THREE MILES ISLAND NUCLEAR STATION, UNIT NO. 1

AMENDMENT TO FACILITY OPERATING LICENSE

Amendment No. 23  
License No. DPR-50

ATTACHMENT TO LICENSE AMENDMENT NO. 23

**FIGURE 5**  
**REV. 2**

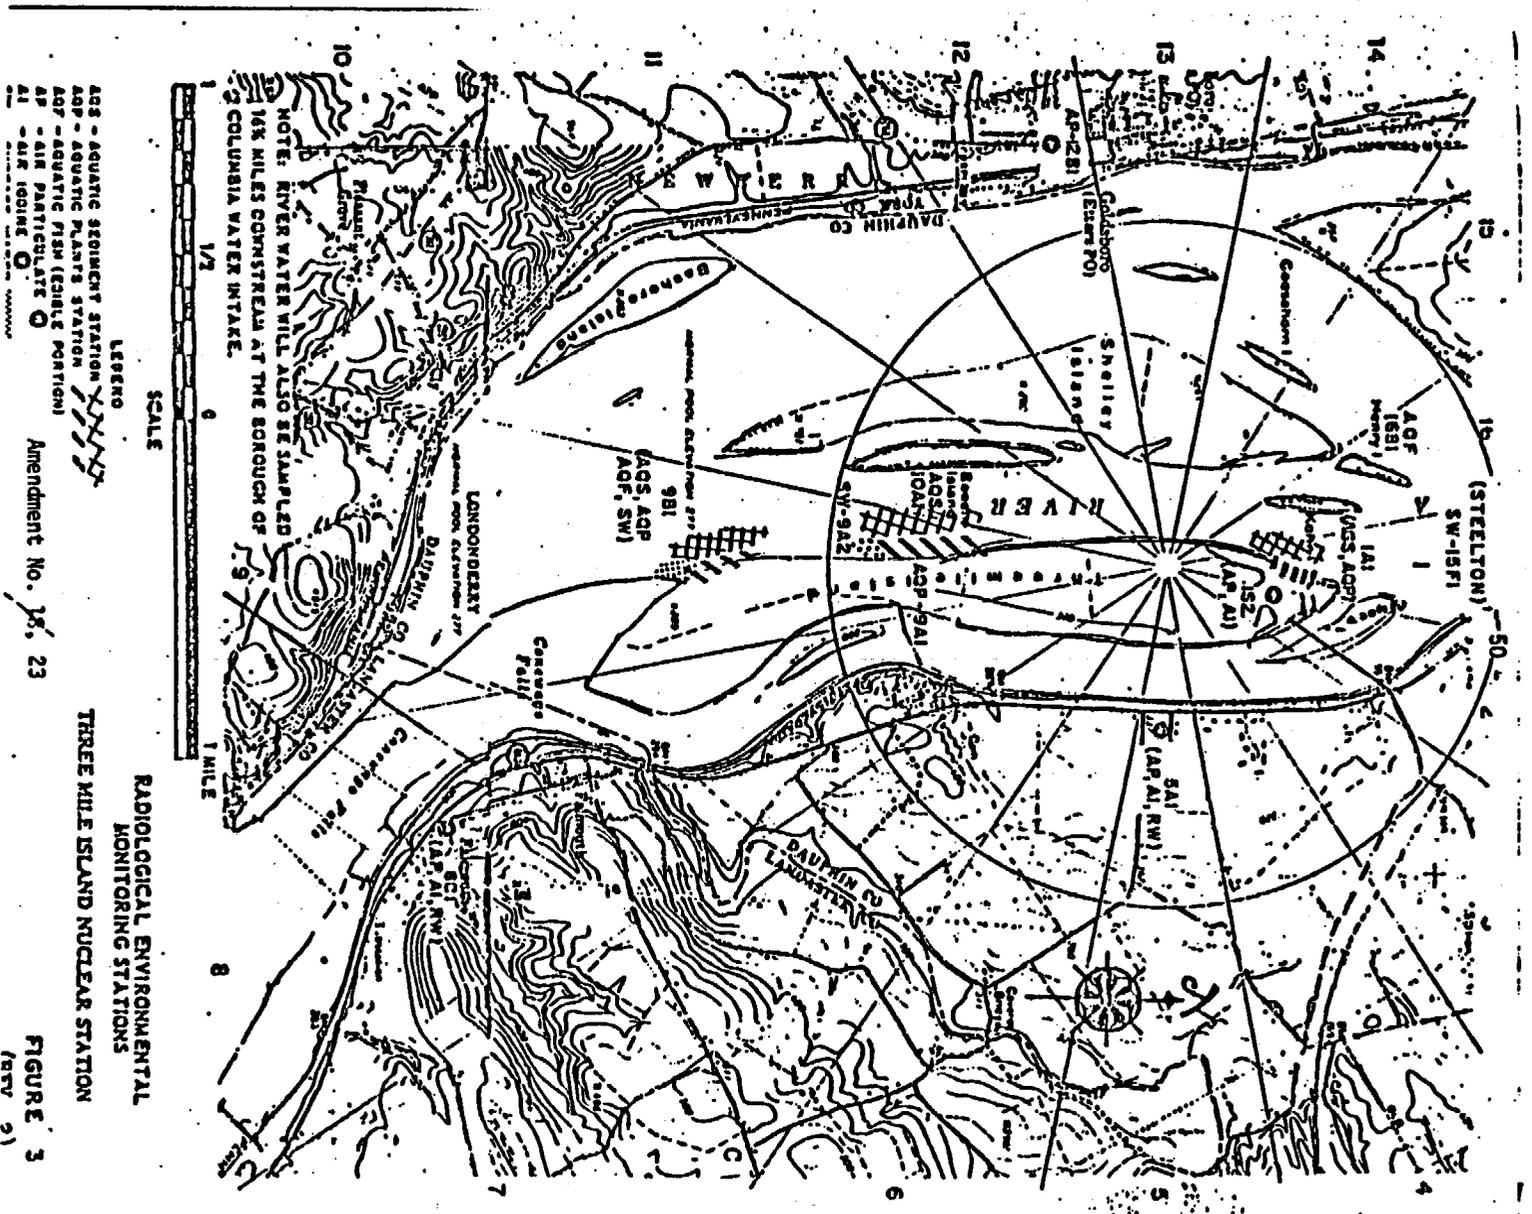
By letter dated July 31, 1975, the licensee requested relocation of the sample stations 4-A-I, 3-I-I and 2-P-I from the construction personnel parking lot to a new location near the southern tip of Three Mile Island, where the stations would be designated TM-AP-9S1, TM-AI-9S1 and TM-RW-9S1. This change was approved by Amendment No. 18 to the Facility Operating License. In attempting to implement this relocation the licensee has encountered legal problems which have prevented his use of the proposed site. By his letter dated November 22, 1976, the licensee has proposed an alternate location (coordinate 8C1) near the east bank of the river and approximately 0.75 mile further downstream (southeast). In this location the samplers will be approximately 2.2 miles ESE of the reactor containment, will be in a low traffic area on ground controlled by the licensee and will be near a populated area. The proposed location also generally corresponds with a monitoring location recommended by the NRC staff in the draft supplement to the Three Mile Island Unit No. 2 Final Environmental Statement (NUREG - 0066). Based on these factors we conclude that the proposed new location is suitable for performing monitoring in this region of the plant environs and therefore, that the proposed relocation is acceptable.
